Subject: AP1000 COL Standard Technical Report Submittal of APP-GW-GLN-019, Revision 2 (TR 103)

The changes within this Technical Report are a compilation of approved design changes to AP1000 Fluid Systems that have not previously been submitted under individual header. This document is sectioned to identify Fluid System changes that have been approved by the Westinghouse Change Control Board, that have not been submitted in previous Technical Reports, and that have had a direct impact on the Design Control Document (DCD). These are predominantly minor changes in system designs that are due to the progression of the detailed design. Each change will be individually identified within this document. The description of these changes can be found within Section II of this document. Additionally, not all of the changes described within this document have been incorporated into Rev. 16 of the AP1000 Design Control Document. The changes to R16 are detailed on pages 144 to 149.

Title: Fluid System Changes

FIGURE 9.2.1-1

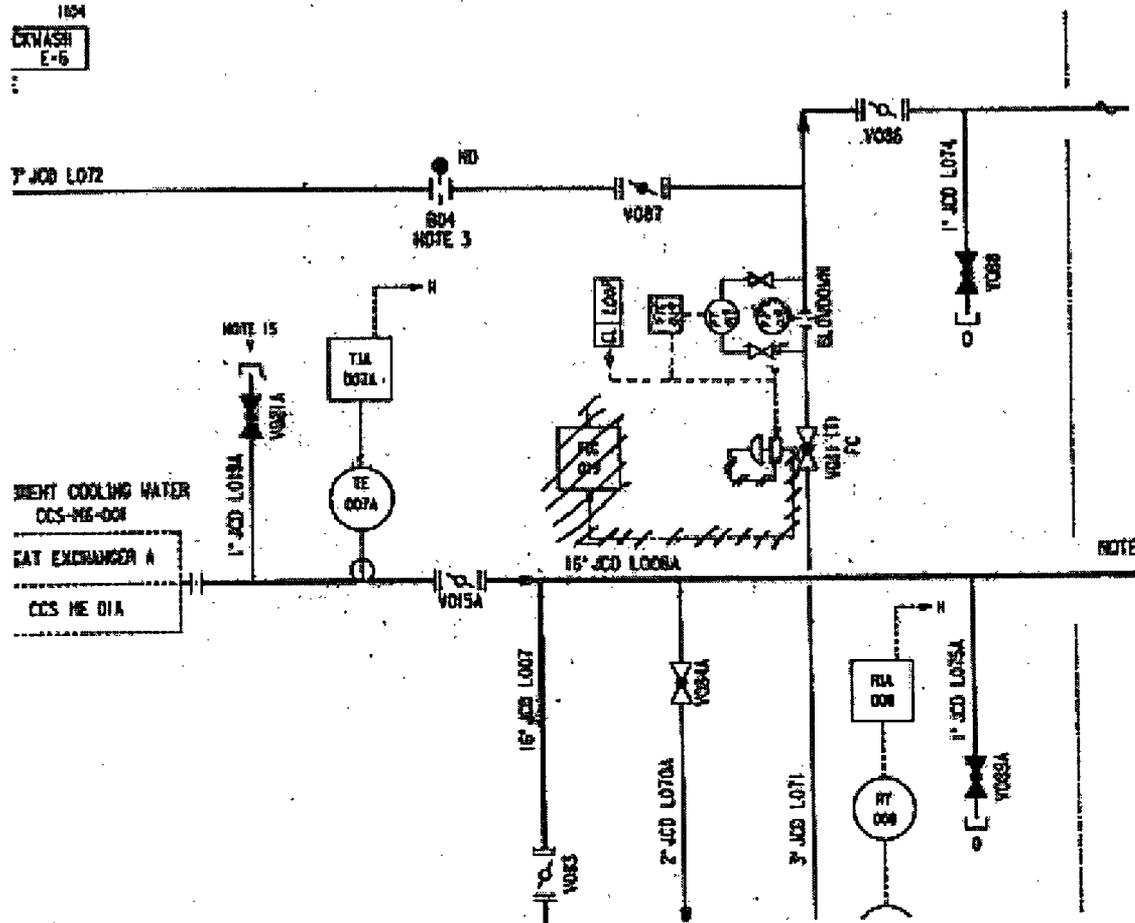
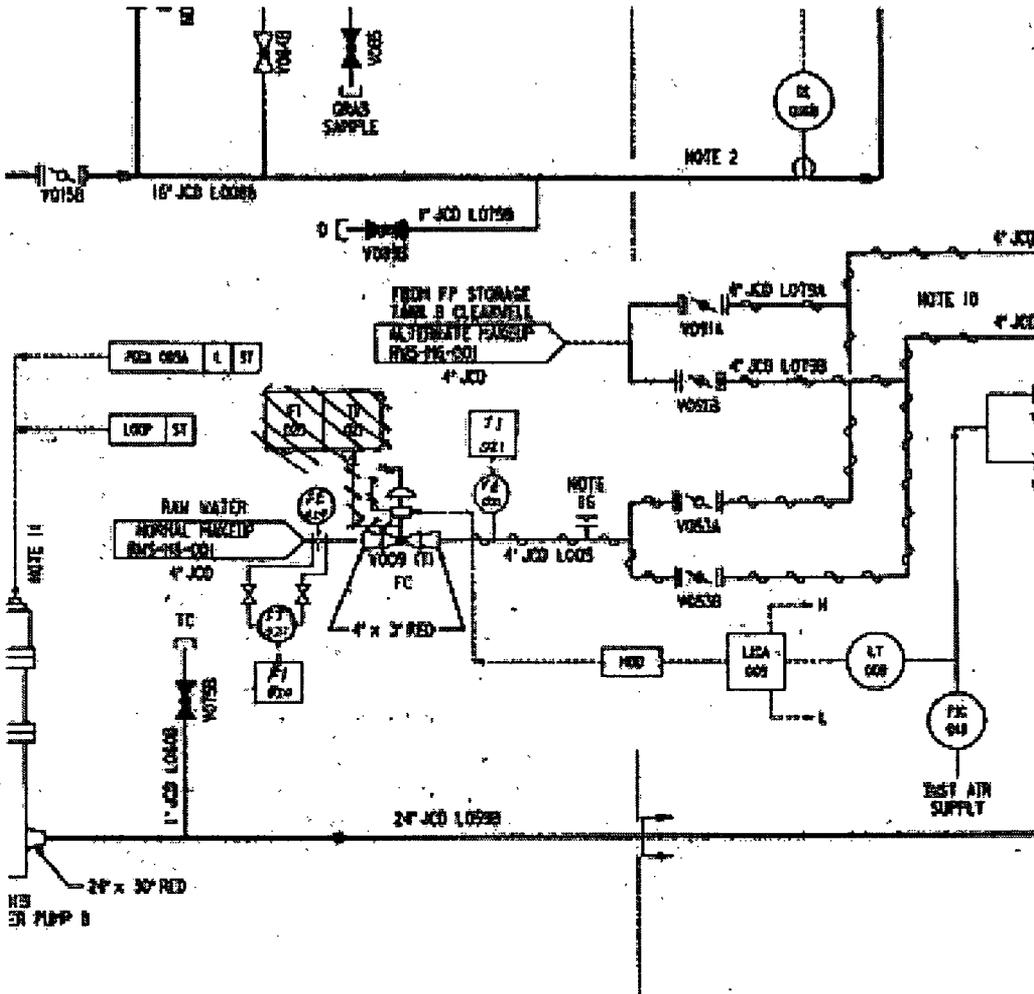
Figure 9.2.1-1 (Service Water System valves V011 and V009) and Figure 9.2.7-1 Sheet 2 of 3 (Central Chilled Water System valves V272A/B, and V261A/B/C/D) have been corrected in accordance with this change.

Figure 9.3.6-1, Sheet 1 of 2

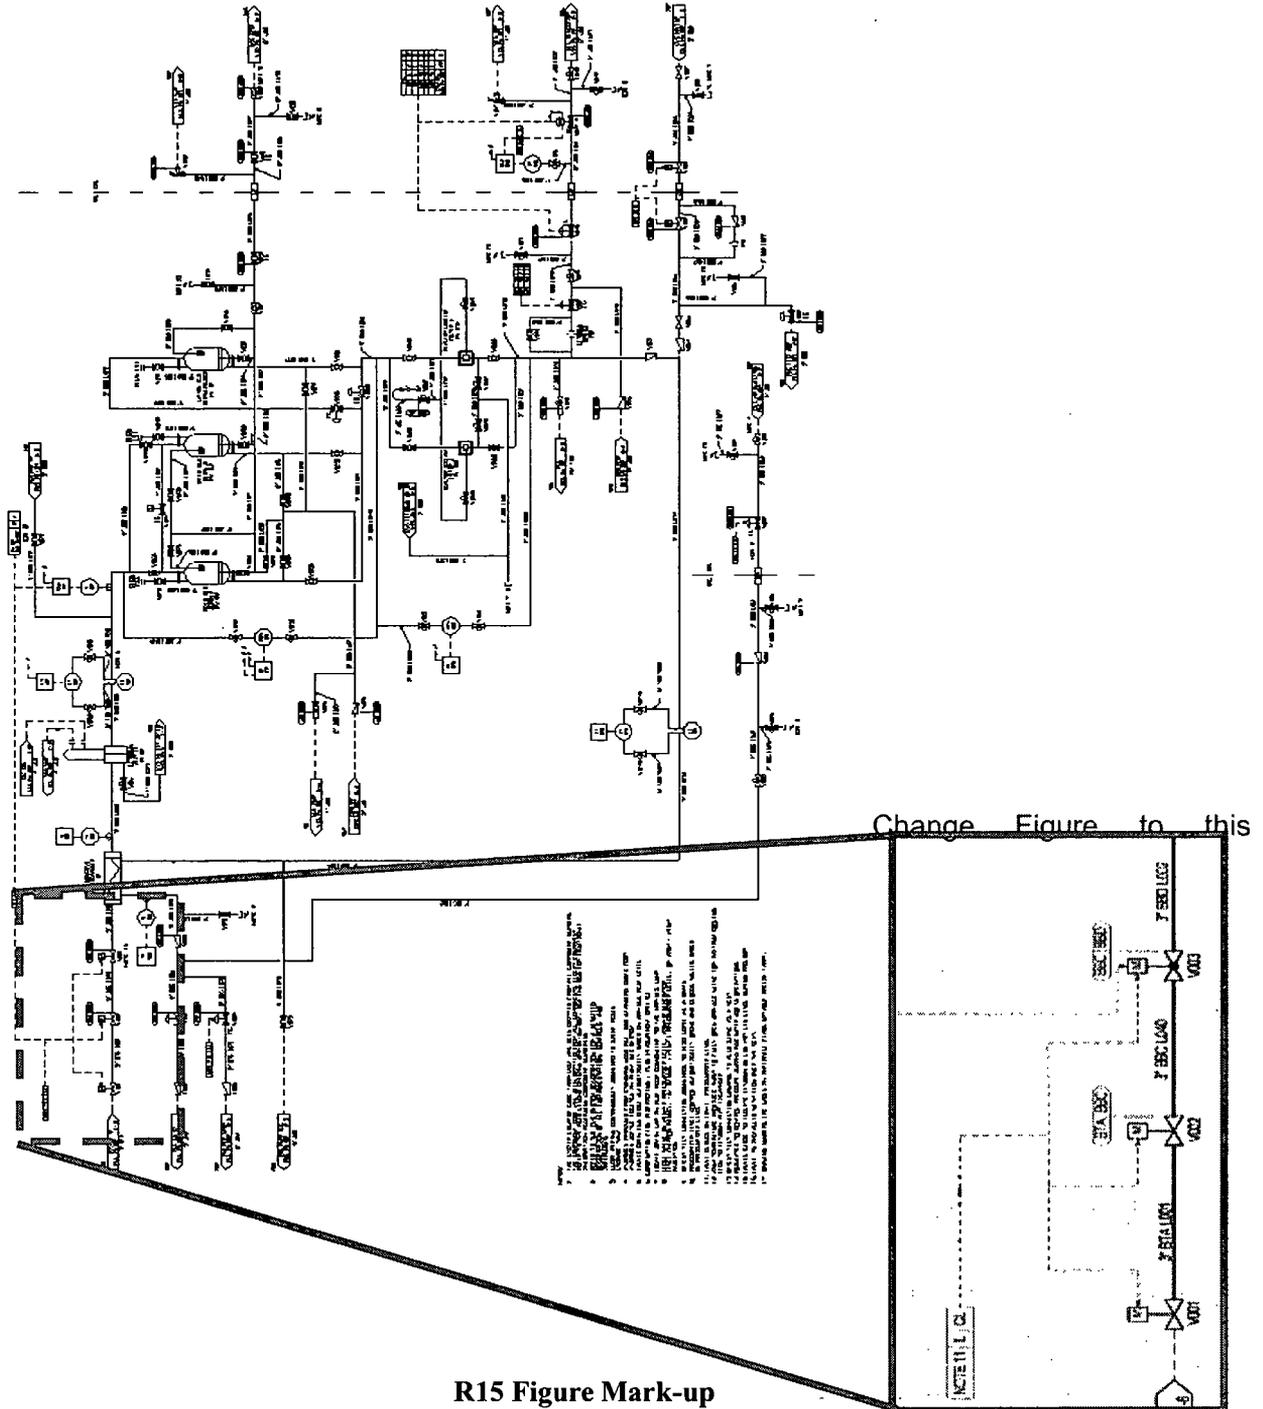
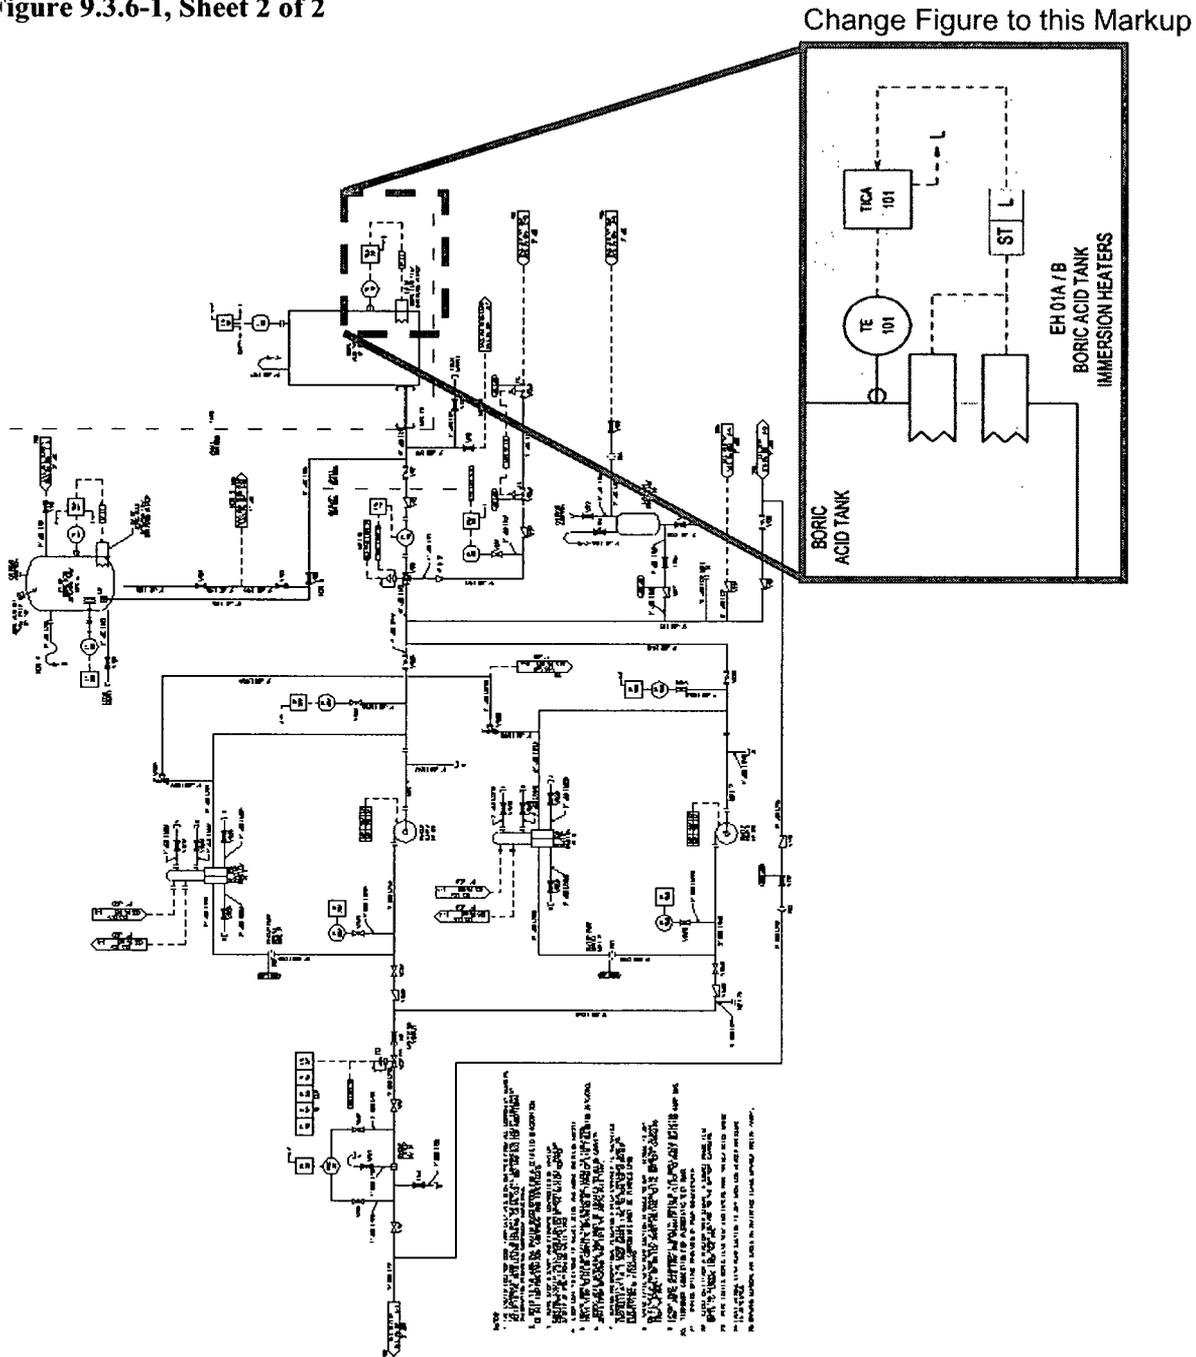
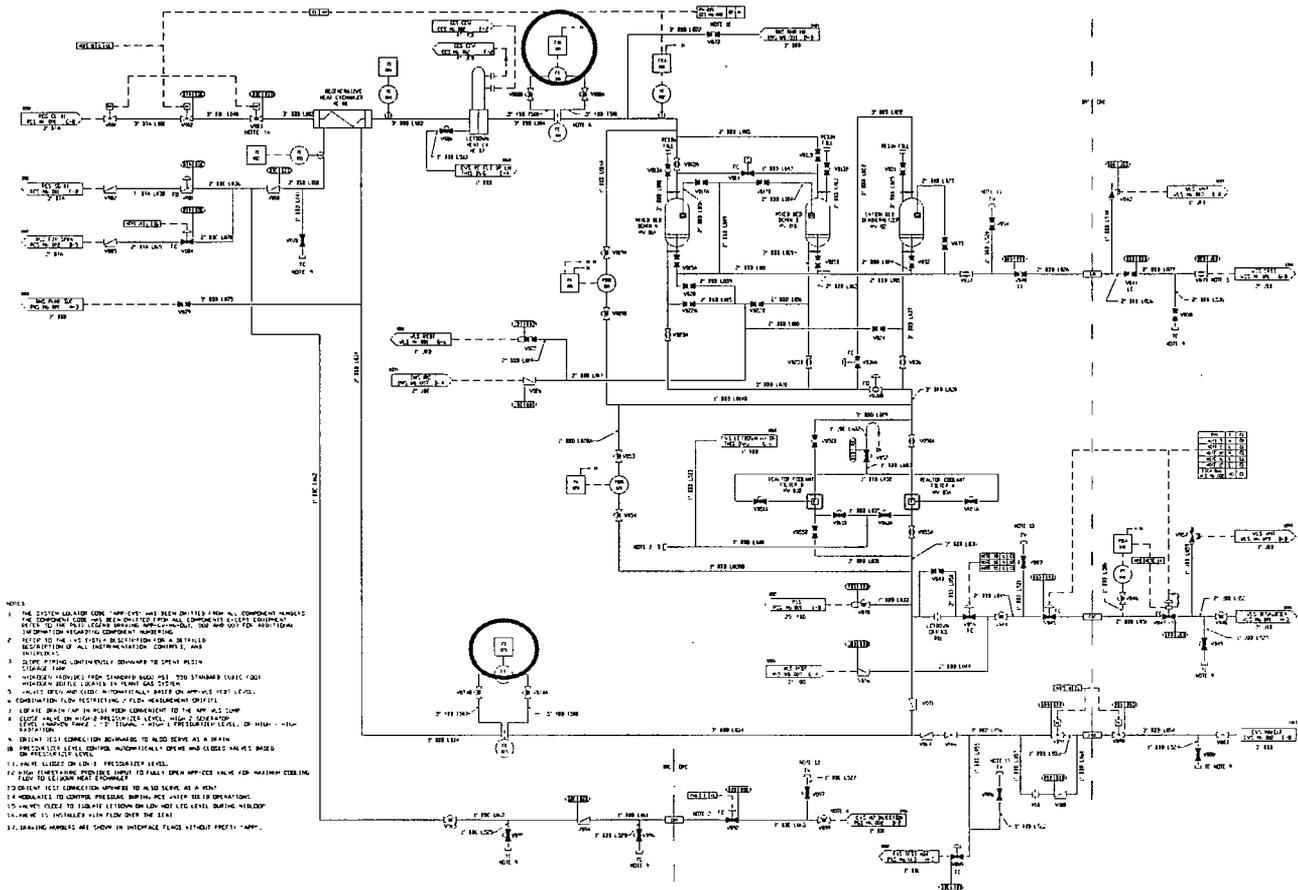
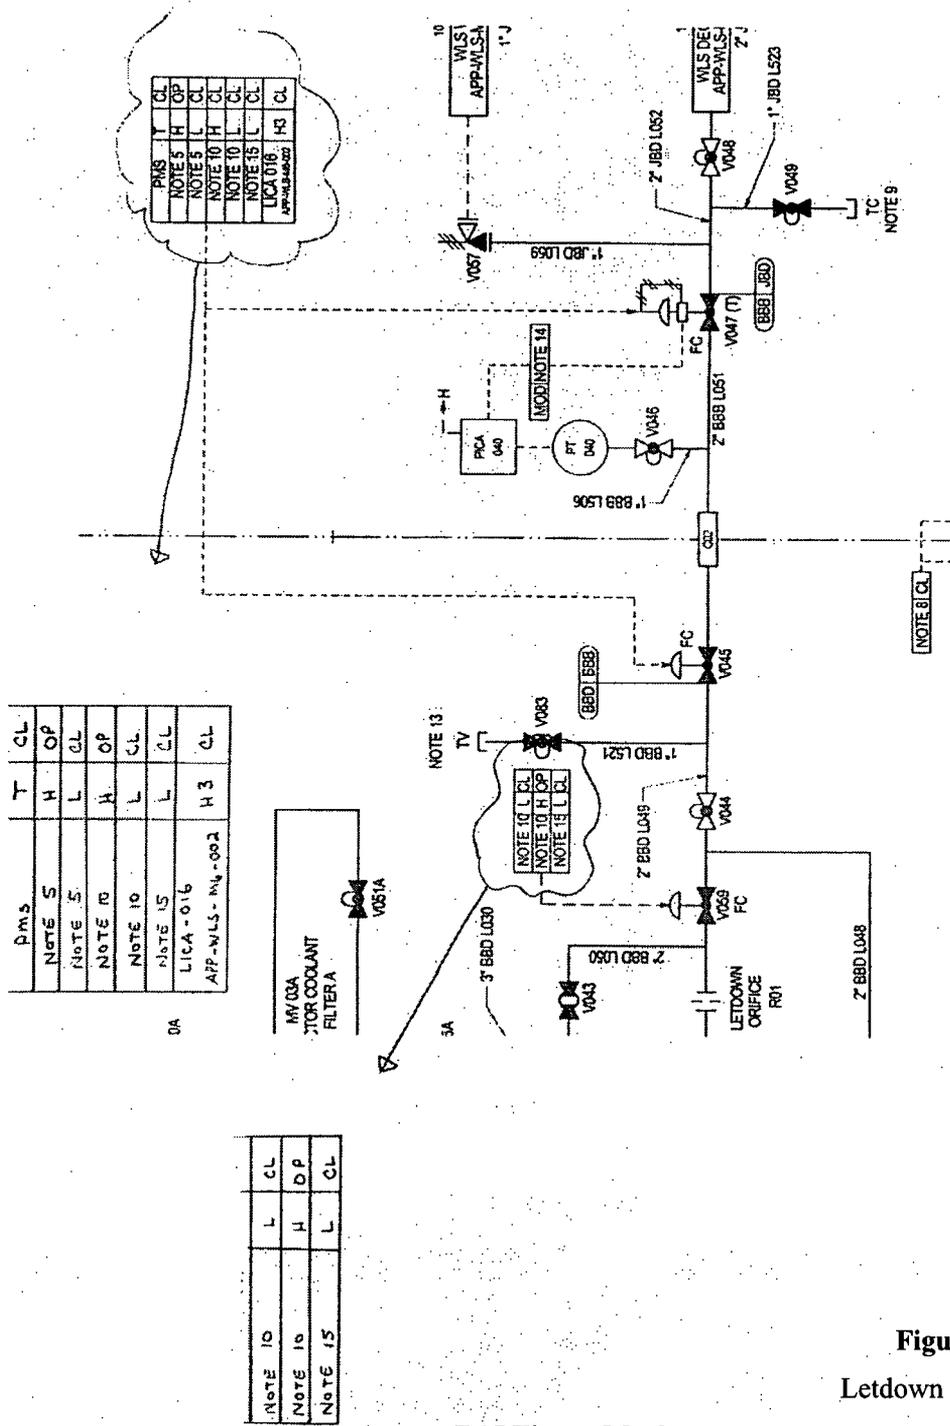
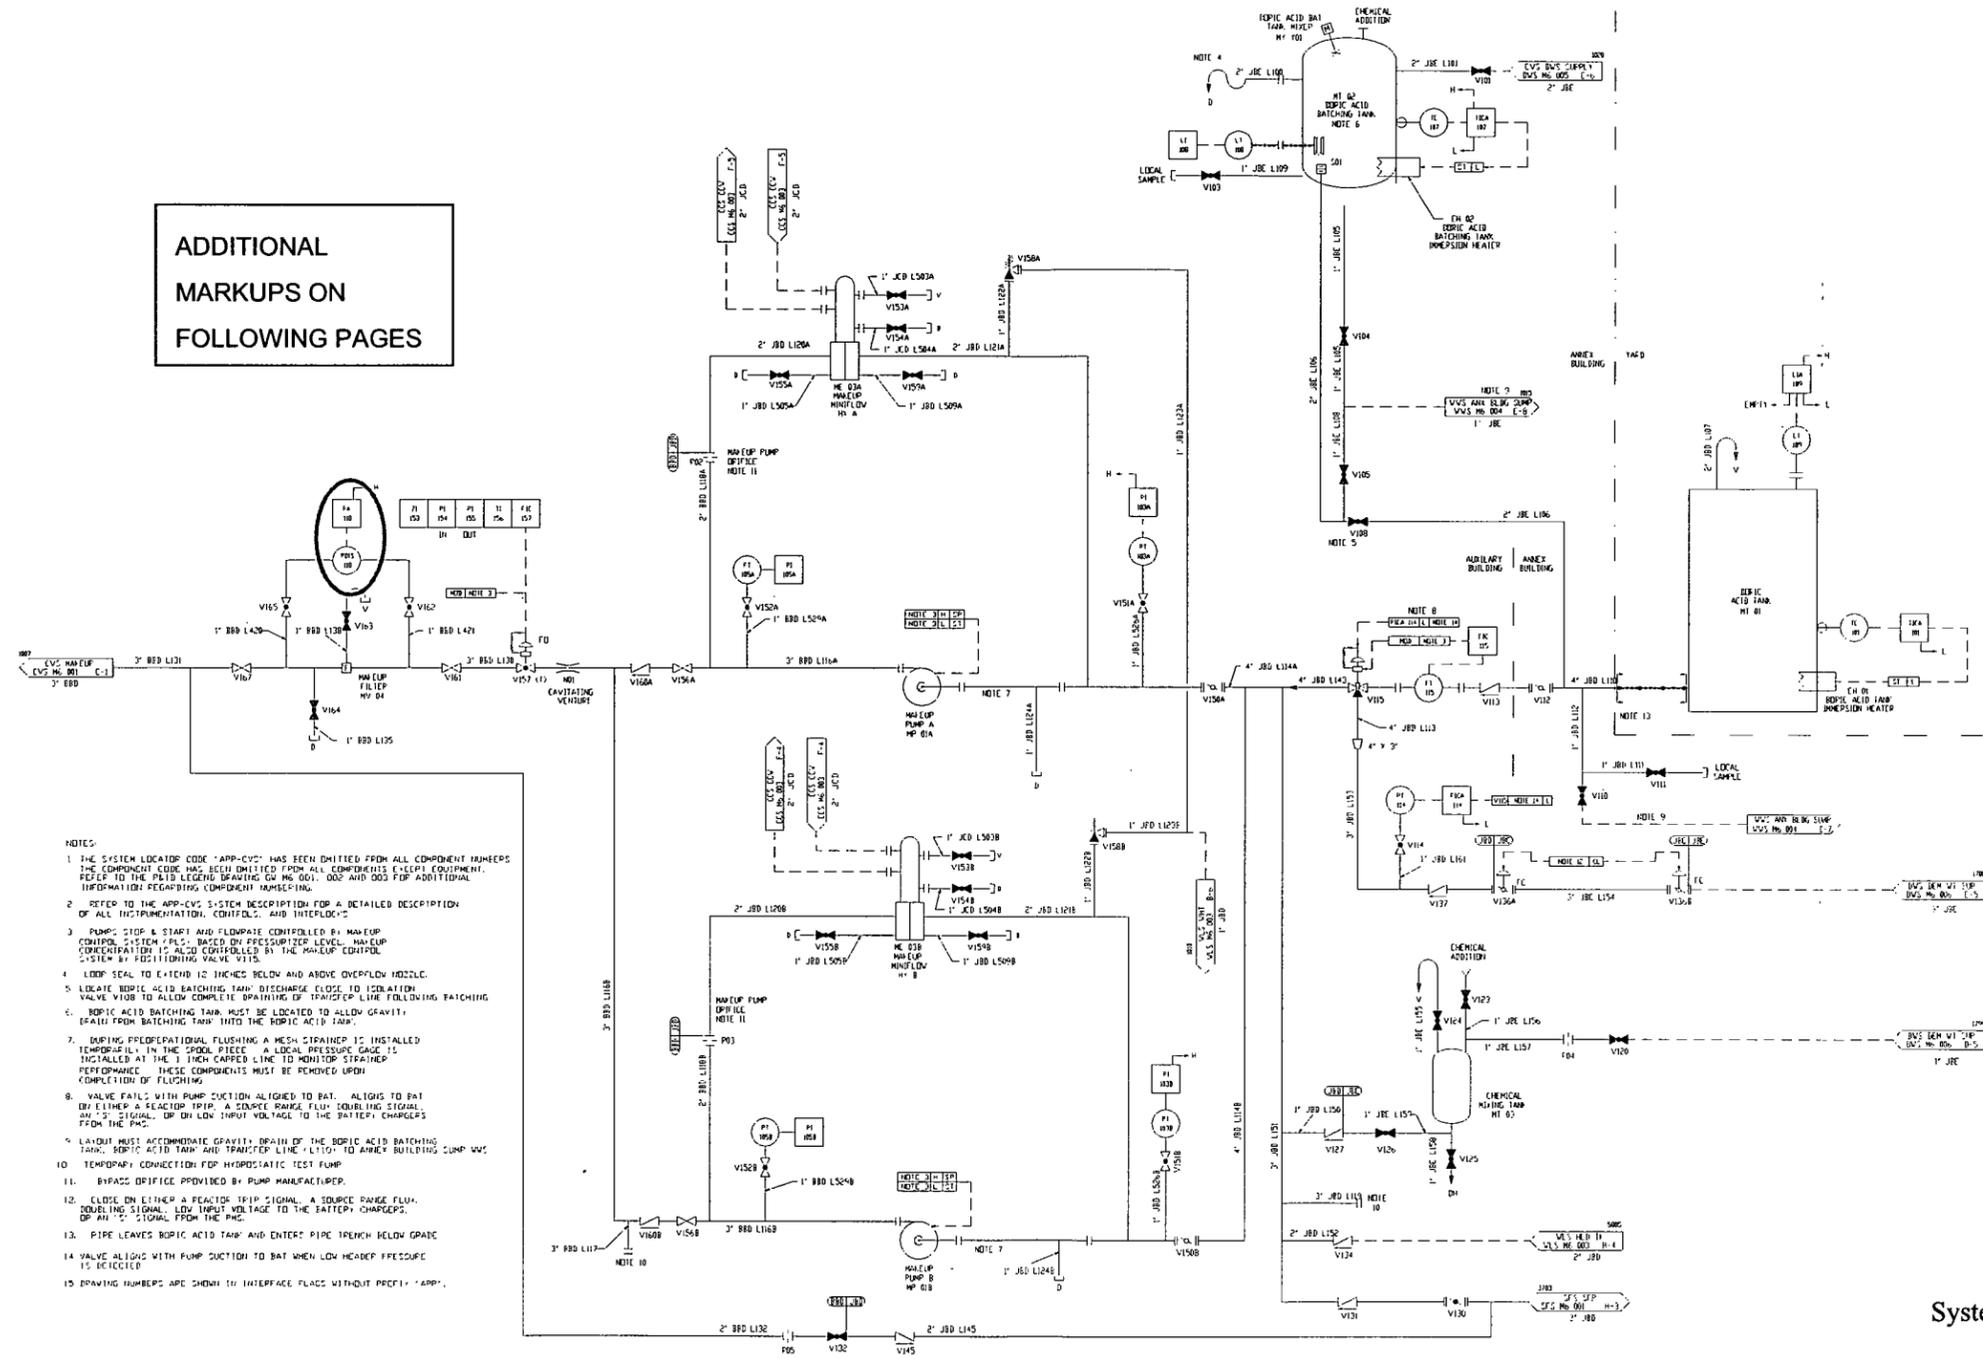
The interlock between valves CVS-PL-V001, 002, 003 and temperature instrument TICA-002 has been revised because having three interlocks increases the potential for inadvertent actuation of system isolation which would result in thermal transient to the CVS heat exchangers, which should be avoided. The present DCD figure shows an interlock between TICA-002 and three purification isolation valves, CVS-PL-V001, V002 and V003 which is used to protect the demineralizer resin beds from excessive temperature. A single MOV closure is sufficient for automatic CVS isolation, and therefore, the interlocks between TICA-002 and CVS-PL-V001 and V002 are deleted as marked on the schematic drawing in Section III. A high alarm and signal to CCS-PL-V221 and a high interlock between CVS-PL-V003 and TICA-002 are sufficient to protect the demineralizer resin beds from overheating.

A standard heating unit for the immersion heaters in tanks has been selected. Depending upon the connection of the heating element, the unit is able to produce either 13.3 kw or 4.43 kw. For extreme weather conditions it has been determined that the Boric Acid Tank will require 16.6 kw of heat to prevent freezing; therefore, two standard heating elements are required. Each heating element will have its own immersion well in the tank, and each will be configured differently. The CVS figure in Tier 2 has been updated to show two heating elements.

During the operation of the boric acid batching tank, there is no need for control room personnel to monitor or control any aspect of the tank operation. An operator locally controls all aspects; therefore, local indication and control of temperature and level is now specified with no remote operation or indication. DCD Figure 9.3.6 has been updated to show this change.

Valve V059 receives a PLS signal on low level during mid-loop operations via the PMS concurrent with valves V045 and V047. Therefore, a note has been added to the CIB, Note 23 "PLS – Closes CVS-V059 to Isolate Letdown on Low Hot Leg Level During Midloop." Updates are shown on DCD Figure 9.3.6.
